ADMINISTRATIVE ADJUSTMENT OF STANDARDS
Tree Retention in Talus

PROJECT: Middle School No. 6 (Talus)

PERMIT NUMBER: AAS20-00001 for SDP19-00002/PRJ18-00020

SUBJECT: **Administrative Adjustment of Standards #4
Significant Tree Retention**

TREE
EXHIBIT

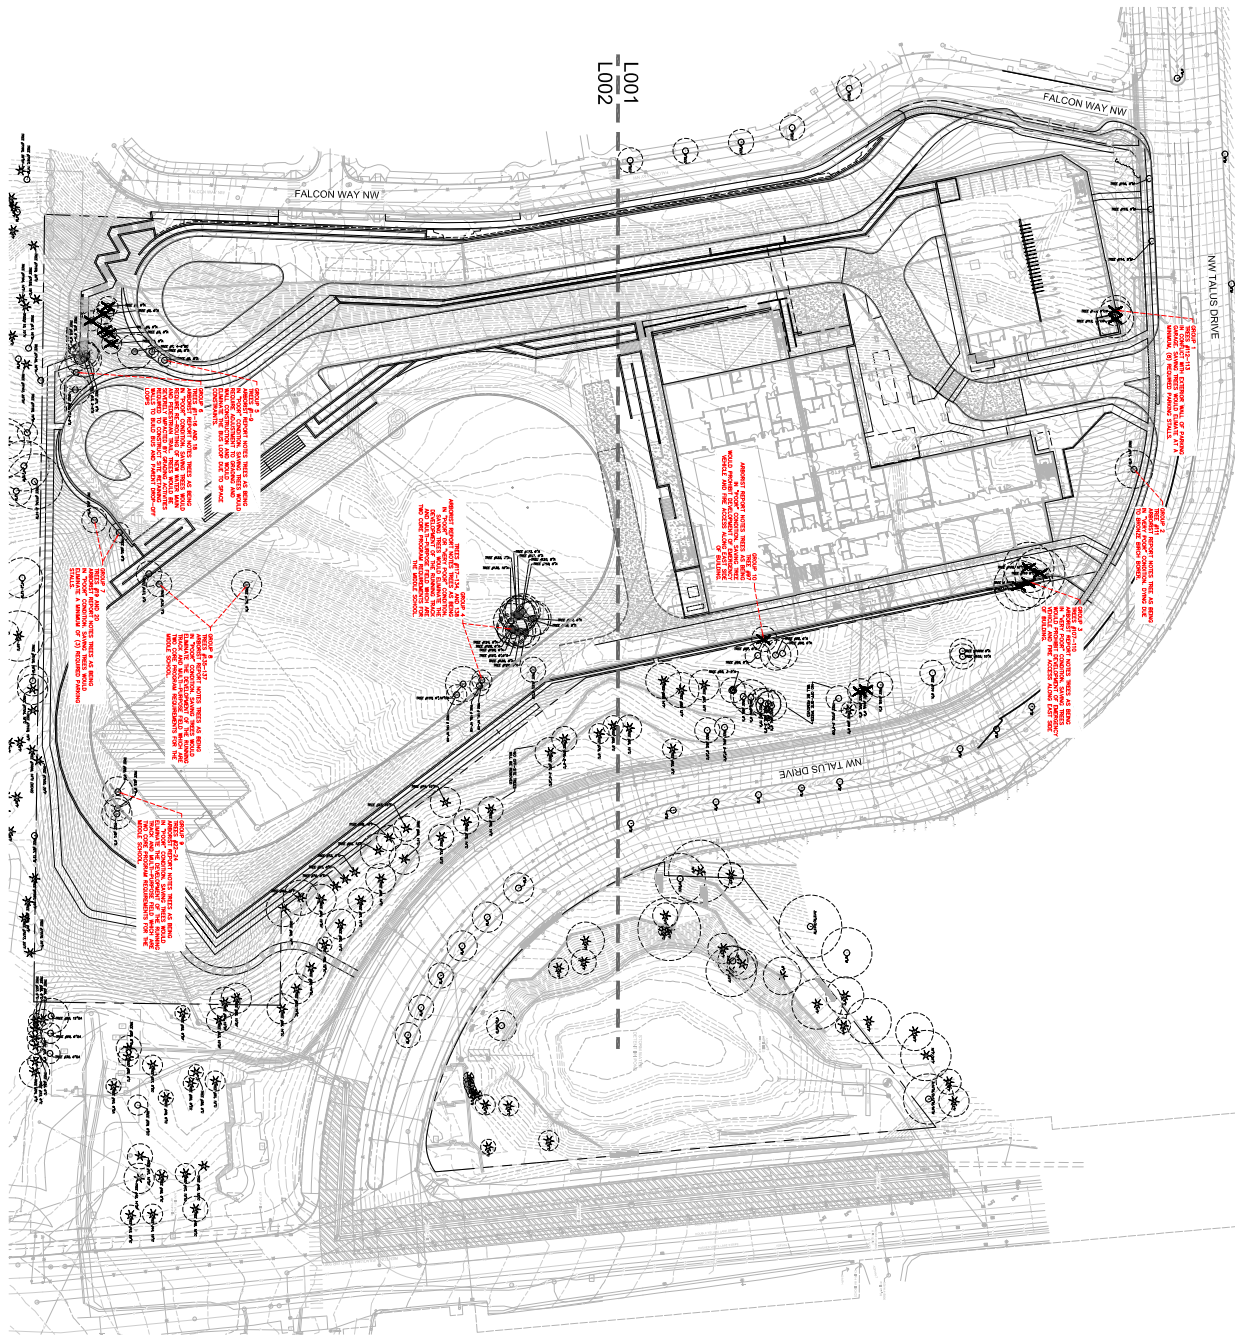
The project has shown that criterion 1, 3, 4 and 6 have been met. Criteria 5 was not applicable. Criteria 2 can not be met with the proposed project development. An Administrative Adjustment of Standards (AAS) is being requested based on the following rationales as they relate to the existing individual tree groupings noted below. Location of tree groupings are identified on the

Trees #112 and 113 are in direct conflict with the northeast exterior wall of the proposed parking garage structure. Saving trees would eliminate at a minimum (8) of the project's required parking stalls.

Tree #111 is noted in the Arborist Report as being in "very poor" health due to bronze birch borer. The trees proximity to the public sidewalk along NW Talus Drive makes it a potential hazard.

Trees #107 – 110 are noted in the Arborist Report as being in "very poor" health. Saving trees would prohibit the development of the emergency vehicle access drive along the east side of the classroom wing of the building.

Trees #117-134 and 138 are noted in the Arborist Report as being in "poor" condition. Saving trees would eliminate the development of the running track and multi-purpose field which are two core program requirements for the middle school.

Trees #1-9 are noted in the Arborist Report as being in "poor" condition. Saving trees would require adjustment to grading and wall construction and would eliminate the bus loop due to space constraints on site. The separate bus loop is a core program requirement of the middle school.

Trees #11-16 and 18 are noted in the Arborist Report as being in "poor" condition. Saving trees would require re-routing of the new water main and pedestrian trail. Trees would be severely impacted by grading activities required to construct retaining walls between bus loop and parent drop-off loop.

Trees #19 and 20 are noted in the Arborist Report as being in "poor" condition. Saving trees would eliminate a minimum of (3) required parking stalls.

Trees #135-137 are noted in the Arborist Report as being in "poor" condition. Saving trees would eliminate the development of the running track and multi-purpose field which are two core program requirements for the middle school.

Trees #22-24 are noted in the Arborist Report as being in "poor" condition. Saving trees would eliminate the development of the running track and multi-purpose field which are two core program requirements for the middle school.

Tree #97 is noted in the Arborist Report as being in "very poor" health. Saving trees would prohibit the development of the emergency vehicle access drive along the east side of the classroom wing of the building.

The following adjustment is approved with conditions:

1. Unless otherwise specified, the adjustment shall be subject to all plans, specifications, and conditions set forth in the application.
2. No Talus Replacement Regulations or Issaquah Municipal Code regulations are modified by this design unless specifically identified through this Administrative Adjustment of Standards for site grading and retaining wall height.
3. Before removing trees from the site, the Applicant shall evaluate site trees smaller than 6 caliper inches in diameter to determine if in areas where minimal grading is occurring (e.g. southwest corner, southeast corner, northern edge) the proposal can comply with

IMC 18.12.1385.B.2 by retaining approximately 34 inches of trees smaller than significant trees. If compliance is possible, then, after the City has confirmed compliance, these trees will be retained and this AAS will be voided. If it is not possible to retain sufficient caliper inches of smaller trees to comply with IMC 18.12.1385.B.2, then the AAS is approved with the conditions as shown, except this Condition #3, and significant trees as shown retained.
